PRODUCT UPDATE

#160A

FGG.4B Plug Shell with Modified Key Location

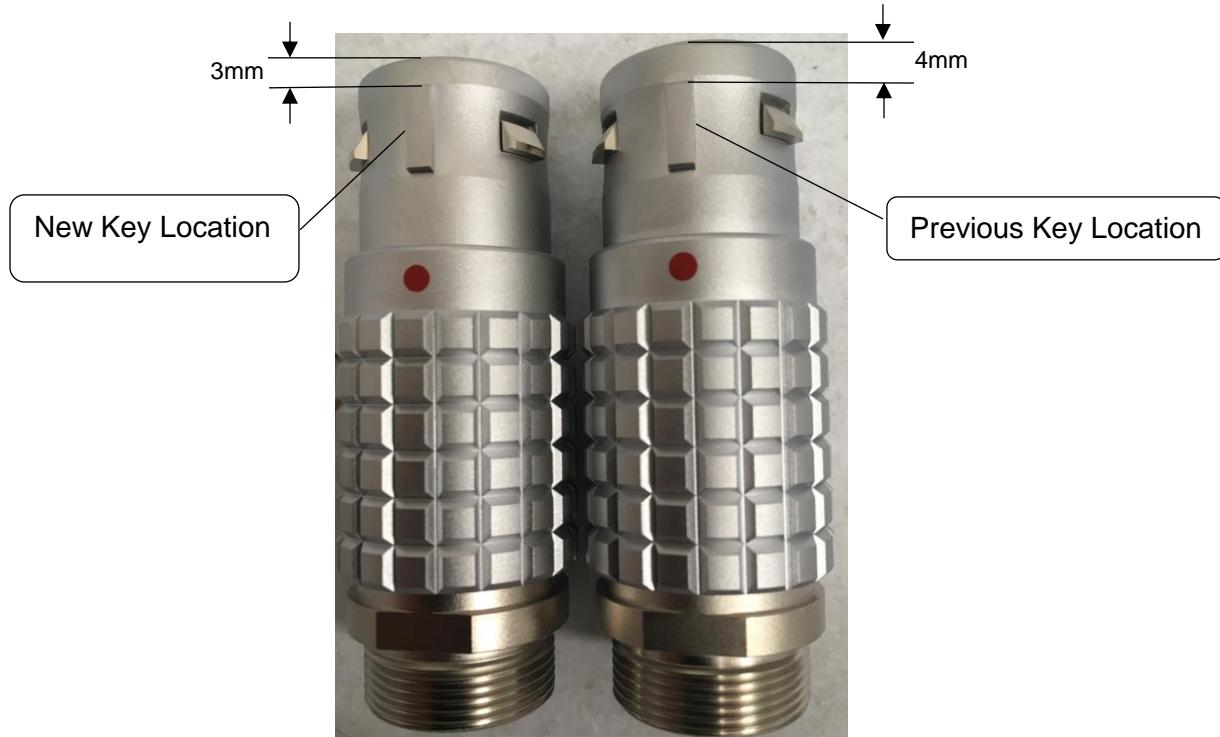
- 1) With reference to Product Update #160 (originally sent in April 2016), the key has been extended to the standard length but remains 1mm closer to the mating interface to improve the ease of mating.
- 2) The new plug shells are compatible with existing receptacles
- 3) The price of the plug is unaffected

- 1) The key utilized by the FGG.4B has been redesigned. It is now the standard length and remains 1mm closer to the mating interface. The intent is to ease the mating to any **E_G.4B**, **H_G.4B**, or **P_G.4B** receptacle, as well as any **RGJ.4B**, **SGJ.4B**, or **SJG.4B** coupler.

- 2) As only the plug has been modified, the new FGG.4B plug is backwards compatible with any receptacle of any style.
- 3) The pricing of the FGG.4B shells, and the resulting connectors that use it, has been unaffected.
